**EASTERN CONNECTICUT
ENVIRONMENTAL REVIEW TEAM
REPORT**

O'KEEFE
PROPERTY
DEVELOPMENT

LEDYARD, CONNECTICUT

REVIEW DATE: JUNE 29, 1989

ALTERNATE LOT ARRANGEMENTS

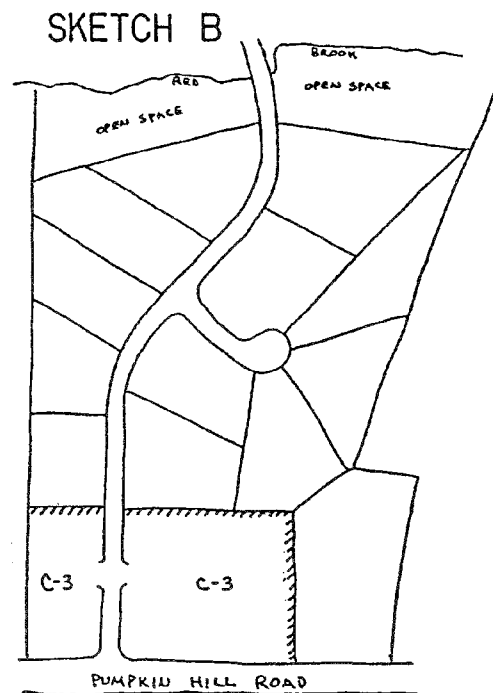
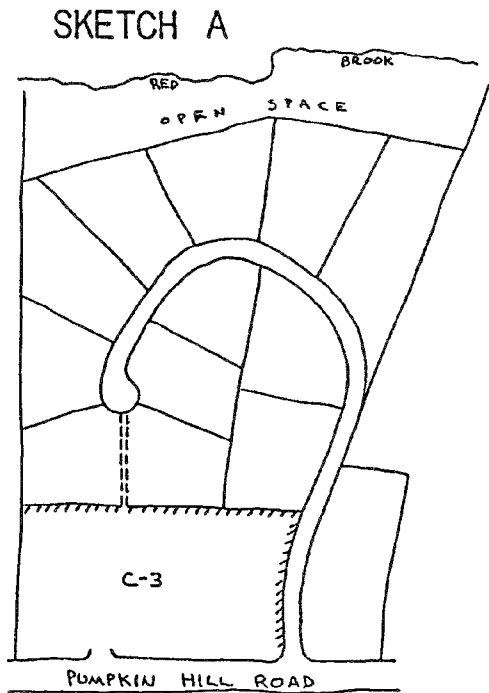
estimated to be 3500 vehicles per day.* This is a lot of traffic on a local road having sub-standard lane widths and virtually no shoulders. Therefore, the numbers of road and driveway intersections should be minimized wherever possible. Two alternatives to the proposed access arrangements are suggested for consideration in the interests of improving traffic safety. These are illustrated below.

Sketch A is intended to totally separate the residential part of the subdivision (including its access) from the commercial lots. The new road system would involve a single intersection with Pumpkin Hill Road, serving only the residential lots. More flexibility is retained for the use of the commercial lots since they would not be split by a second road right-of-way. A pedestrian access could be reserved between the cul-de-sac and the commercial property, depending on the nature of the property use.

Sketch B is recommended if it appears likely that the proposed road will be extended to Shewville Road. As a connector road between Shewville Road and Pumpkin Hill Road, part of its traffic is likely to be generated by the commercial uses that occupy the subject property. In that event, driveways to such uses would connect with the proposed road, rather than directly to Pumpkin Hill Road. All traffic turning from or into Pumpkin Hill Road would do so at a single intersection, simplifying traffic control measures.
